# **Design Integrity Report**

Detailed State Significant Development Application  
**Crows Nest Site C Over Station Development**

**Reference:** SMCSWSCN-SMC-SCN-EM-REP-000016

Figure 3: Indicative location of youth hub (no longer proposed) (DRP No. 5) (3 December 2019)

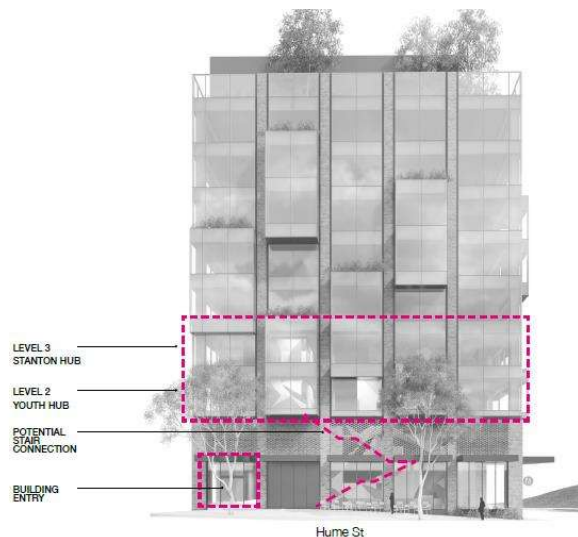
The DRP supported commercial land uses for Site C OSD (DRP No. 3). The design team explored the inclusion of community uses within the building such as a child care centre, youth hub, co-working spaces, event spaces, or meeting rooms and collaboration spaces (DRP Nos. 4 and 5). Following consultation with North Sydney Council, it was decided to remove the community use from the scheme and propose a full commercial building instead. Bicycle parking and end of trip facilities were proposed on the first floor for use by the commercial tenants (DRP No. 6).

Figure 9: Built form design concepts (DRP No. 6) (31 March 2020)

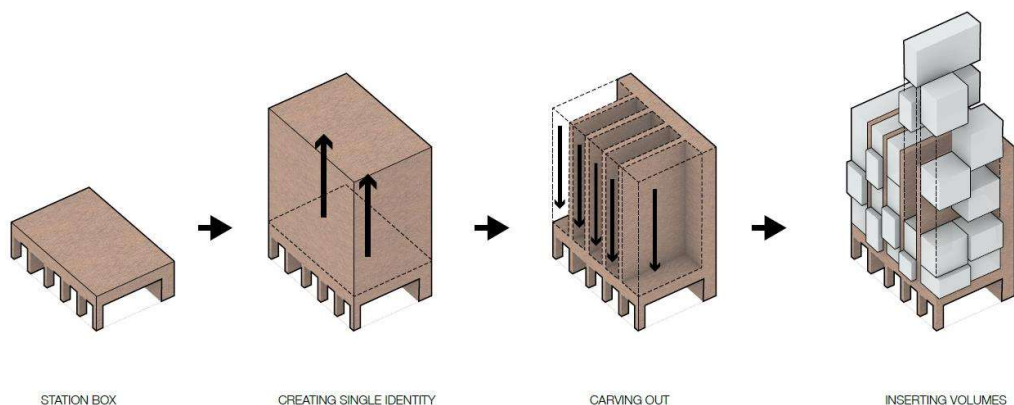
The DRP expressed concerns that the building lacked ‘tectonic clarity’ due to the thinness of the brick columns above the podium, the lack of connection and strength of the columns, and the lack of definition and framing of the top of the building (DRP No. 5). Further design development of the brick pillars was requested by the DRP.

In DRP No. 6, the design team presented the built form design concept and options on how the brick pillars could be integrated with the façade design and architectural expression. The design team’s preferred option expressed the brick pillars as thin vertical columns and enabled the use of glazing across the eastern façade.

Figure 16: Roof planting detail (DRP No. 9) (19 March 2021)

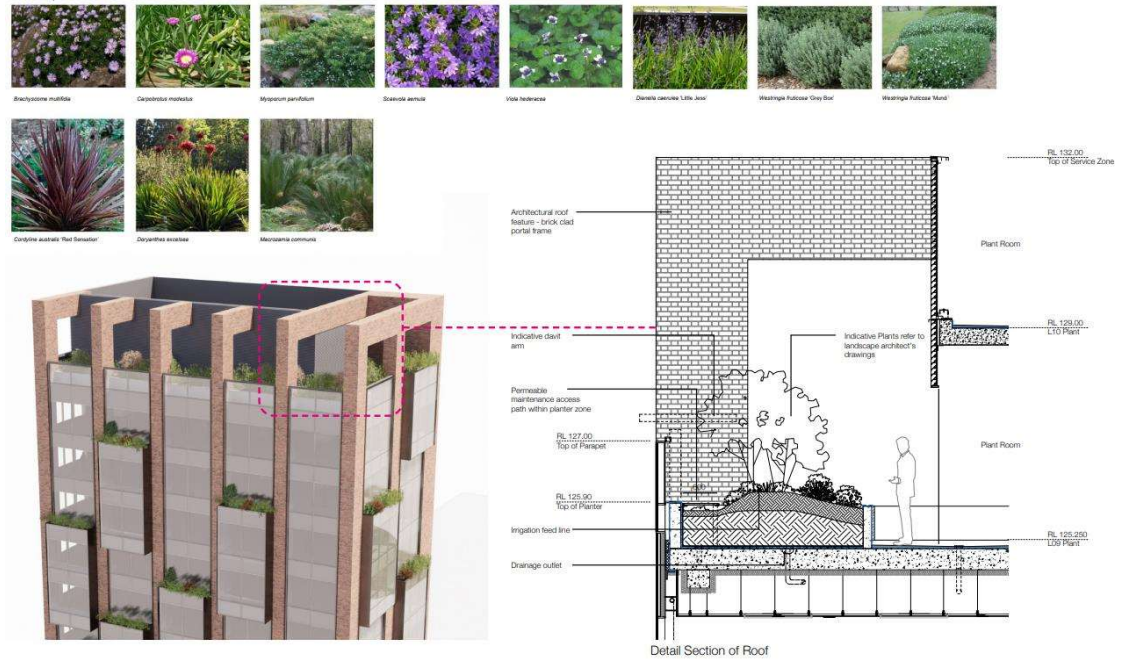
The DRP recommended further design work on the planter boxes at roof level and above the projecting windows to ensure they could be accessed for maintenance (DRP No. 7).

While the DRP has noted the additional information presented by the design team at DRP No. 9, the Panel remain concerned that the maintenance of the planters would not occur regularly and has recommended that a maintenance regime be included as part of the conditions of planning approval.

In response to the DRP comments, further detailed design was undertaken for the roof top landscape and façade planter boxes, including selection of low maintenance species and detailing minimum soil depths, irrigation feed lines and drainage outlets (see Figures 16 to 18) (DRP No. 9).
